Well Name: WHITE STAR FED Well Location: T17S / R29E / SEC 29 / County or Parish/State: EDDY /

Type of Action: Plug and Abandonment

# White Star Fed 9 P&A Procedure

#### Permanent Abandonment of Federal Wells Conditions of Approval

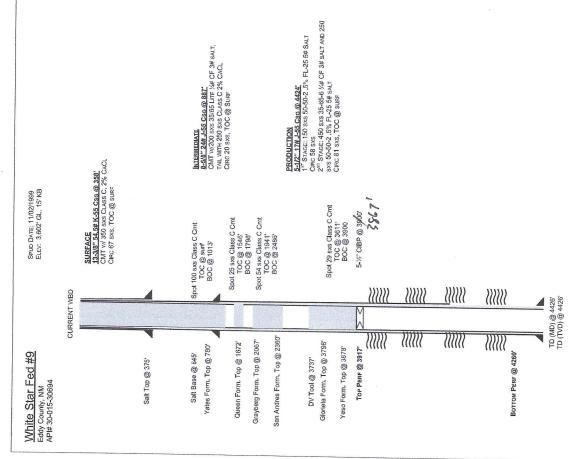
- 1. POOH with all tubing and rods in the hole.
- 2. Set 5-1/2" CIBP at 3900'. Pressure test casing to 500psi for 30mins. Run CBL from 3900' to surface. Spot 29 sxs of Class C Cmt from 3900'-3611'. WOC and Tag. (Yeso, Glorieta, DV Tool)
- 3. Plug 2: Spot 54 sxs Class C Cmt from 2486'-1941'. WOC and tag. (San Andres, Grayberg)
- 4. Plug 3: Spot 25 sxs Class C Cmt from 1798'-1546'. WOC and tag. (Queen)
- 5. Plug 4: Spot 100 sxs Class C Cmt from 1013'-Surface. WOC and tag. (Yates, Salt Base, Salt Top-Surface)
- 6. Ensure all annuli are cemented to surface. Cut-off wellhead. Weld on dryhole marker.
